SNUPPS

August 31, 1981

SLNRC 81-078 FILE: 0541
SUBJ: NRC Request for Additional Information - Materials Engineering

Docket Nos: STN 50-482, STN 50-483, and STN 50-486

Figure 1233-1
CALLAWAY UNIT 1 REACTOR VESSEL
BELTLINE REGION/MATERIAL IDENTIFICATION-LOCATION

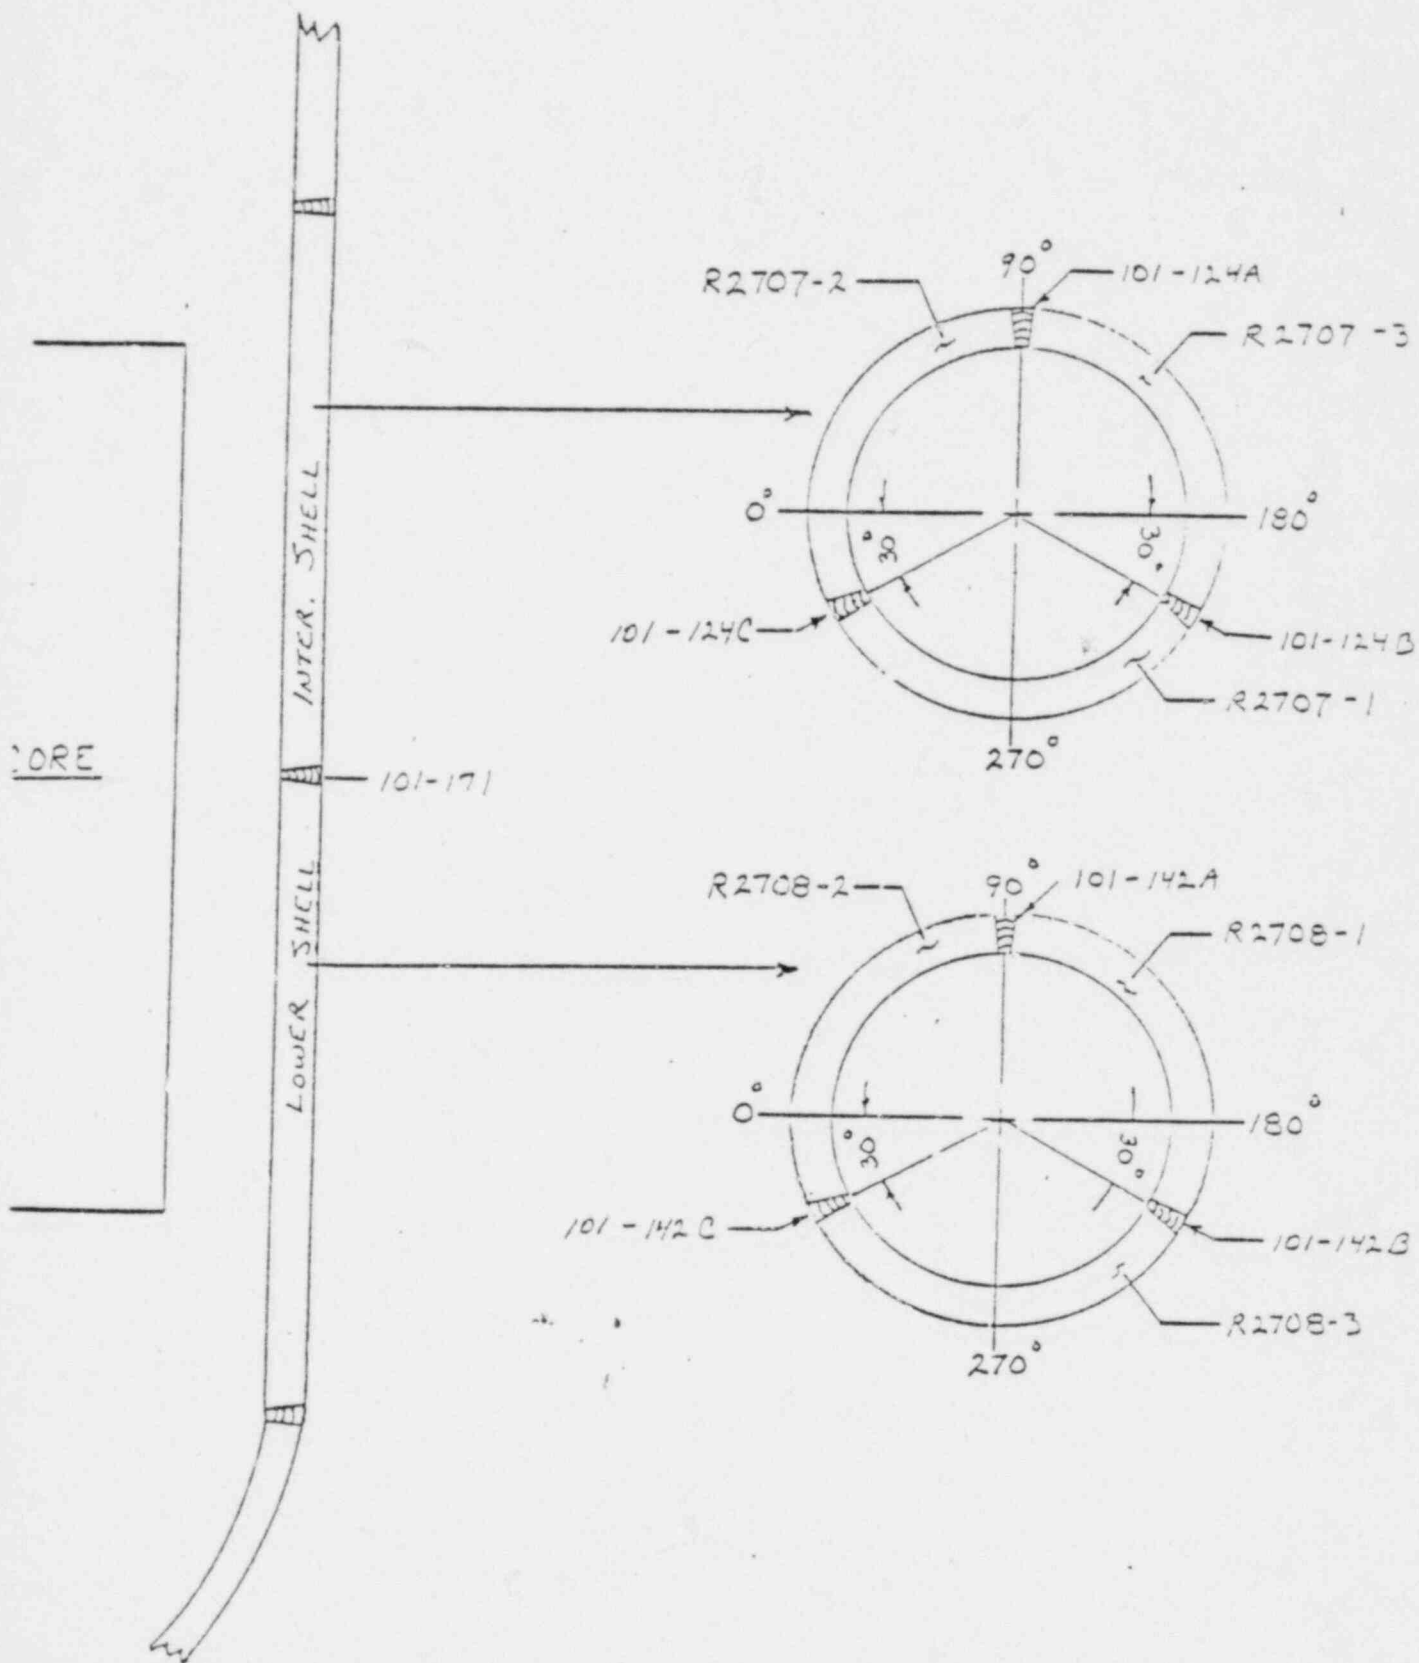
Q123.3 To demonstrate compliance with the beltline material test requirements of Paragraph III.C.2 of Appendix G, 10 CFR Part 50:

- a. Provide a schematic for the reactor vessel showing all welds, plates and/or forgings in the beltline. Welds should be identified by shop control number, weld procedure qualification number, the heat of filler metal, and type and batch of flux. Provide the chemical composition for these welds (particularly Cu, P, and S content).
- b. Indicate the post-weld heat treatment used in the fabrication of the test welds.
- c. Indicate the plates used to fabricate the test welds.
- d. Indicate whether the test specimen for the longitudinal seams were removed from excess material and welds in the vessel shell course following completion of the longitudinal weld joint.

Figure 123.3-1 identifies the location of the beltline materials and welds for the Callaway Unit 1 reactor vessel. Weld identification information for these welds is given in Table 123.3-1.

The test weldment is fabricated as a separate weld, not as an extension of a longitudinal weld seam.
